**Subject:** MHI's Responses to US-APWR DCD RAI NO. 754-5617 REVISION 3 (SRP 14.03.06)

Responses to Request for Additional Information No. 754-5617  
Revision 3

**RAI NO.:** NO. 754-5617 REVISION 3  
**SRP SECTION:** 14.03.06 - ELECTRICAL SYSTEMS - INSPECTIONS, TESTS,  
ANALYSES, AND ACCEPTANCE CRITERIA  
**APPLICATION SECTION:** 14.3.6  
**DATE OF RAI ISSUE:** 05/10/2011

Figure 9.5.4-1 Gas Turbine Generator Fuel Oil Storage and Transfer System Schematic Diagram

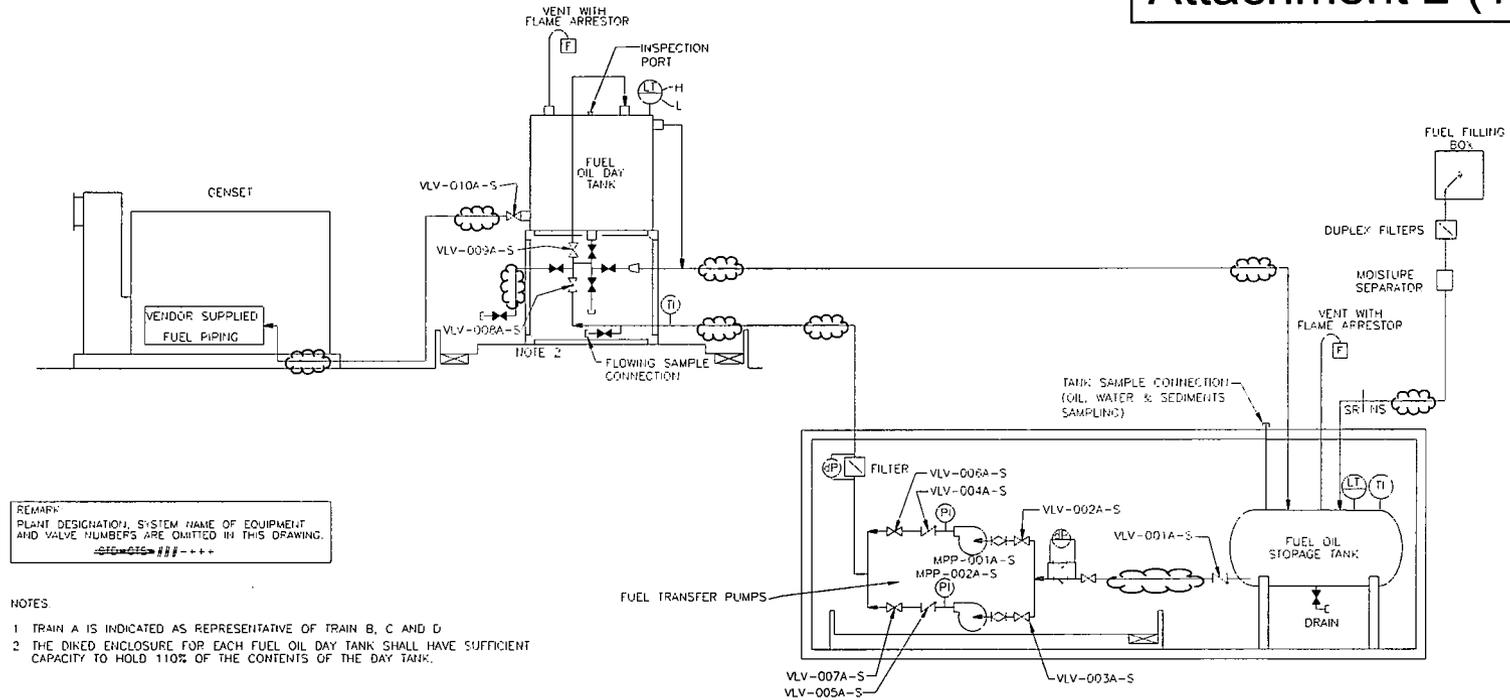
Rev 3 of US-APWR DCD, Table 2.6.4-2 – According to this table, the starting air system piping and valves are ASME Section III, Class 3 from the discharge of the starting air compressors through to the piping connection for the air starter at the GTG skid. According to US-APWR DCD Tier 2 Figure 9.5.6-1 (Rev 2), the starting air system is nonsafety-related up to the inlet of the check valve at the inlet of each starting air receiver. The applicant should address this inconsistency and revise the DCD accordingly.

US-APWR DCD Revision 3 Tier 2 Figure 9.5.6-1 appropriately indicates ASME Code boundaries between ASME Code Section III and non-Code piping. The starting air system is ASME Code Section III up to interface of air starter of GENSET, and inside of GENSET is non ASME Code Section III. Although Figure 9.5.6-1 appropriately indicates the boundaries, the description of flexible connection legend is unsuitable and, thus, will be deleted. MHI will also revise Figure 9.5.4-1 and 9.5.6-1 for the same reason.

US-APWR DCD Revision 3 Tier 1 Table 2.6.4-2, Tier 2 Figure 9.5.6.1 and Figure 9.5.4.1 will be revised as described above and shown in the Attachment 1 and Attachment 2.
